SUBMITTER No.	664	ISSUE REFERENCE:	9118
SUBMITTER TYPE	Council	TOR CATEGORY	Water Resources
NAME	Whitsunday Regional Council	RELEVANT EIS SECTION

SUBMITTER No.	419	ISSUE REFERENCE:	4126
SUBMITTER TYPE	Government	TOR CATEGORY	Water Resources (Surface Water)
NAME	DERM	RELEVANT EIS SECTION	Treatment of construction waters with aluminium sulphate (p130-132)

Figure 2. Hydraulic modelling results demonstrating compliance with DERM and ACARP guidelines

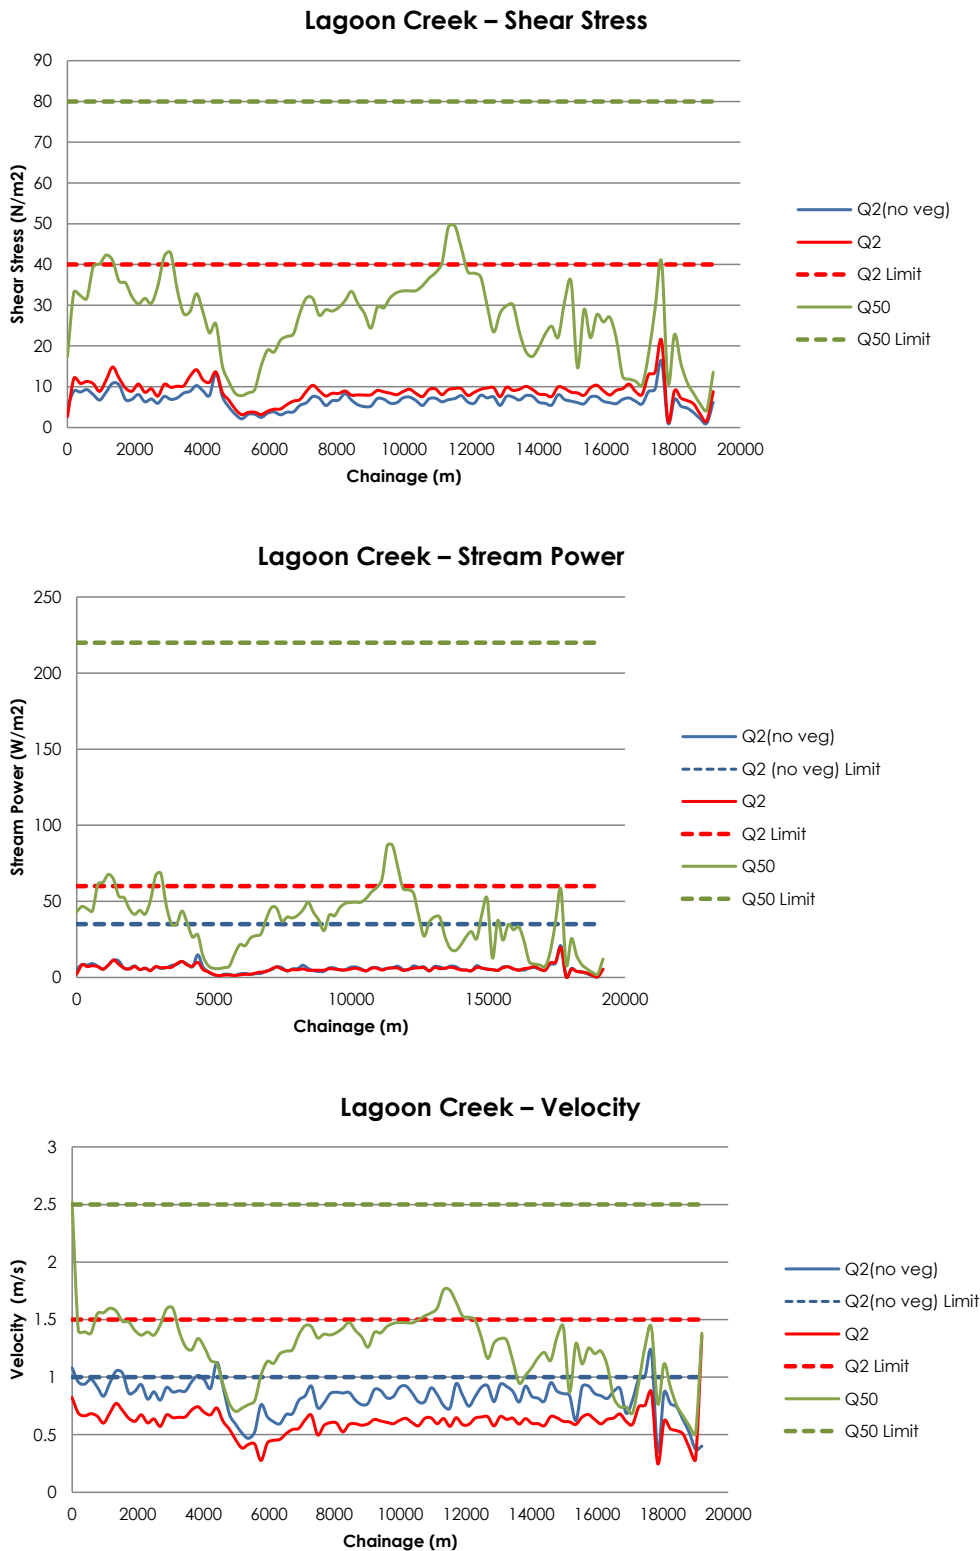
The two Tallarenha Creek diversions are of concern. There does not appear to be enough background data to provide appropriate design and mitigation measures for the diversions to be successful.

Diversion of Tallarenha Creek

There is no diversion of Tallarenha Creek proposed. Lagoon Creek downstream of the confluence with Tallarenha Creek and Beta Creek is proposed to be diverted to prevent flooding of key mine infrastructure. The Lagoon Creek diversion has been designed to comply with ACARP and DERM Guidelines for watercourse diversions. The basis of design and predicted hydraulic characteristics of the proposed creek diversions are described in the *Mine Site Creek Diversion and Flooding* report contained in *Appendices – Volume 2* of this SEIS.
